Access Compliance Report Public Rights-of-Way (Curb Ramps)

Main Street: FRANKLIN_WAY Cross Street: NEWBURY_WAY Location: SE

ADA ID: RPAT211104135205 Ramp Type: Type 4 - Parallel Initial Pass/Fail: Pass Overall Compliance: No Severity Score: 15

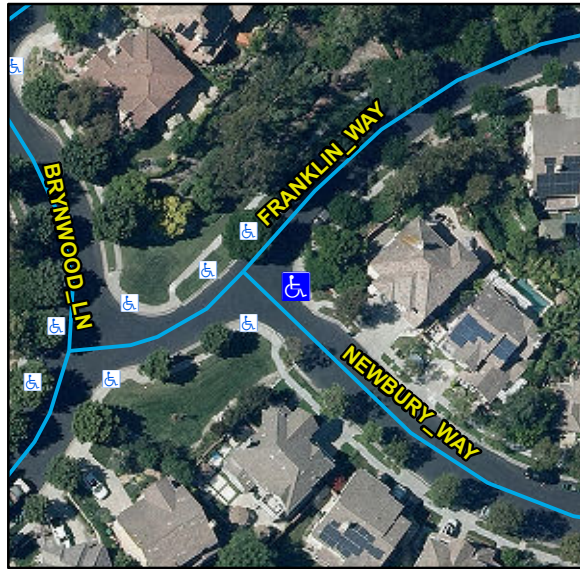
R204.3, R305, R304.5.4, R304.5.3, STD 1115

Remove & Replace Curb Ramp With Two New Directional Ramps or Equivalent. Remove & Replace Gutter.
